1986 Pontiac 6000 STE Low Pitch Noise From Rear Disc Brakes

Figure 1

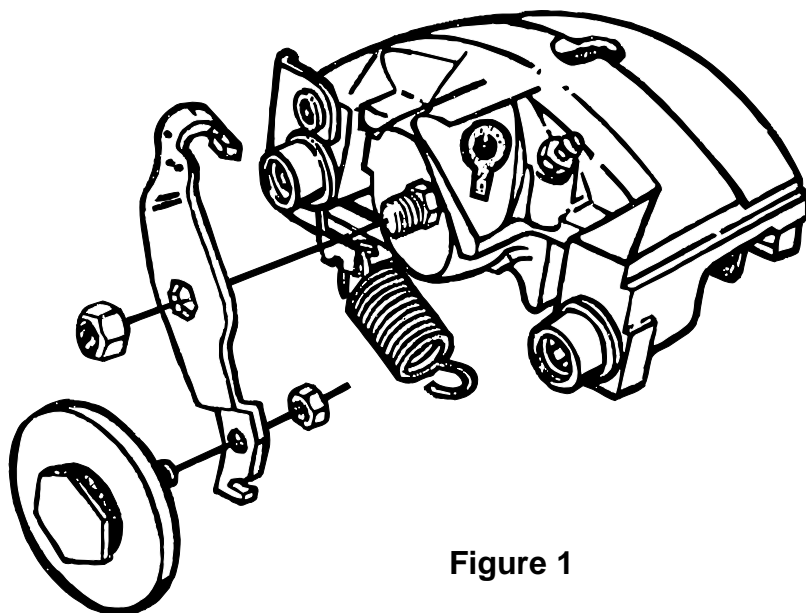
A low pitched moaning noise may be heard from the rear brakes on some Pontiac 6000 STE vehicles under light braking. The noise itself is a low frequency, unlike brake squeal and may also be noticed as a vibration felt through the body of the vehicle.

In order to eliminate this condition, it will be necessary to add a dampener kit, available from G.M. (Part Number 18014586), which consists of two dampener weights, two caliper brake levers (left and right), and two parking brake lever nuts.

Installation requires removal of the existing lever return spring. Next, install the replacement lever re-attach the parking brake lever return spring and install the dampener to the parking brake lever (Figure 1). When installing the dampener **DO NOT** use a wrench on the hex head directly behind the dampener, (between the dampener weight and parking brake lever: Arrow in Figure 2) as this could cause damage to the dampener assembly.
